<b>AMENDMENT OF SOLICITATION/MODIFICATION OF CONTRACT</b>				1. CONTRACT ID CODE	PAGE 1 OF 3 PAGES
2. AMENDMENT/MODIFICATION NO. AMENDMENT NO. 0003		3. EFFECTIVE DATE 07/12/10	4. REQUISITION/PURCHASE REQ. NO.	5. PROJECT NO. (If applicable) 09-0205	
6. ISSUED BY CODE		CODE mks	7. ADMINISTERED BY (If other than Item 6) CODE See Item 6		
Officer in Charge of Construction MCI-East 1005 Michael Road Camp Lejeune, NC 28547-2521					
8. NAME AND ADDRESS OF CONTRACTOR (No., street, county, State and ZIP Code)				(X)	9A. AMENDMENT OF SOLICITATION NO. N40085-09-R-0205
				X	9B. DATED (SEE ITEM 11) 06/25/10
					10A. MODIFICATION OF CONTRACT/ORDER NO.
					10B. DATED (SEE ITEM 11)
CODE	FACILITY CODE

09-0205, Renovations of Galley, Building NH100

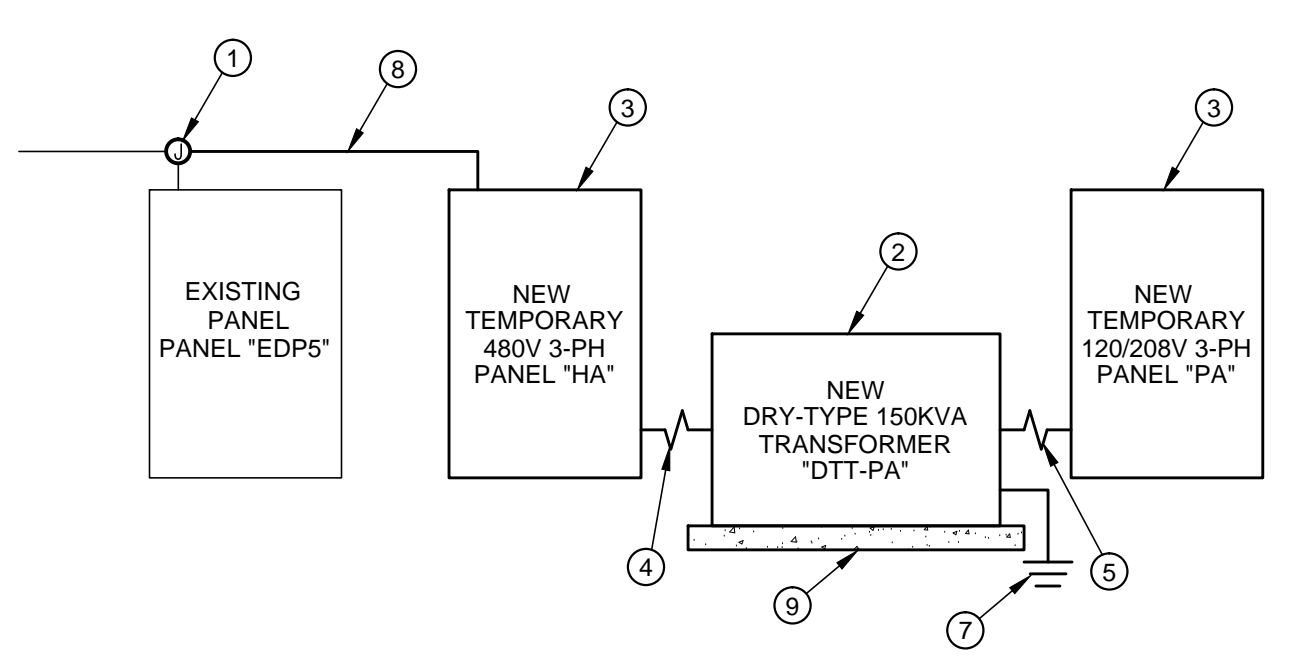
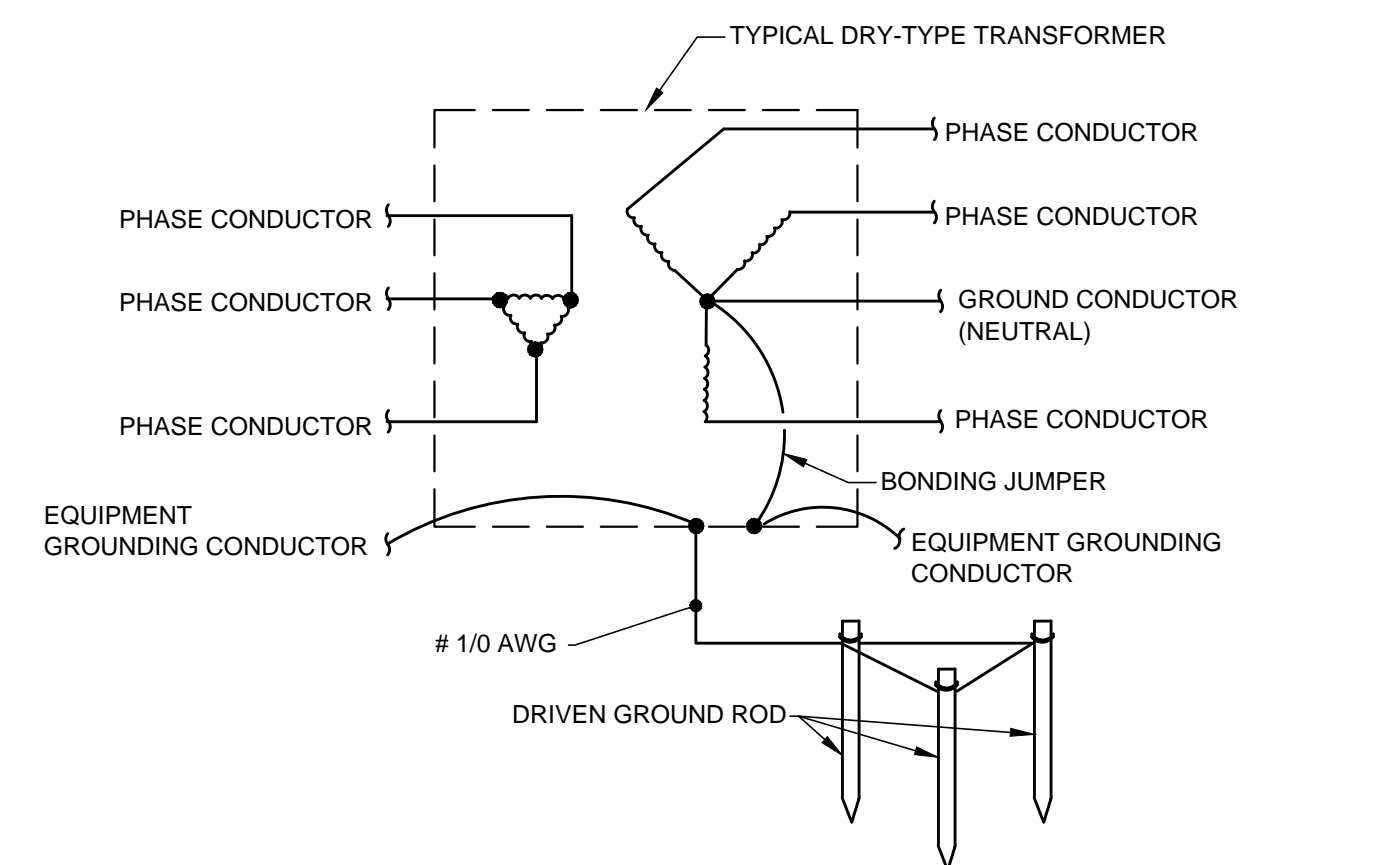
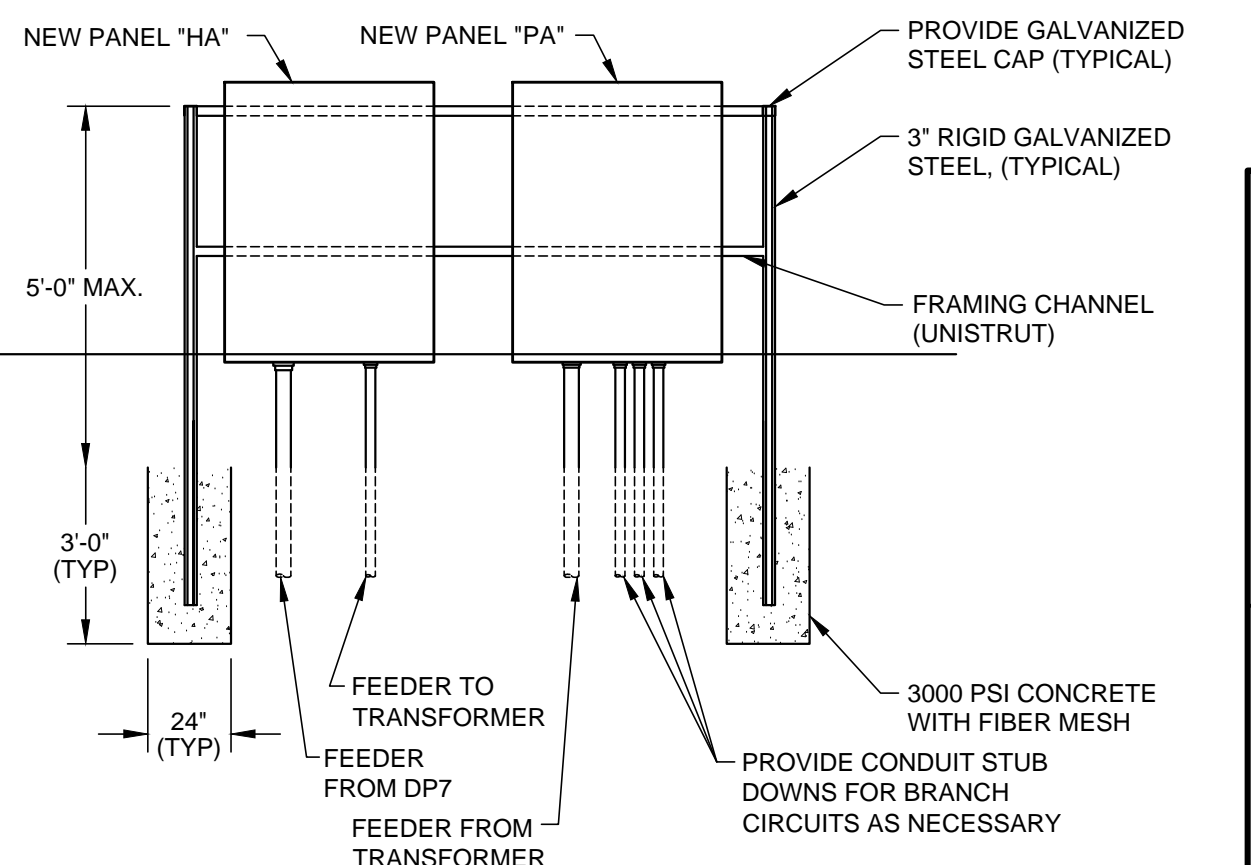
1. Delete Sheet E-100, NAVFAC number 60005741. Replace with attached Sheet E-100. NAVFAC number will remain the same.
2. Question: What are the vertical reinforcement requirements for the new masonry work?
2. Answer: No vertical reinforcing is required for new masonry work.
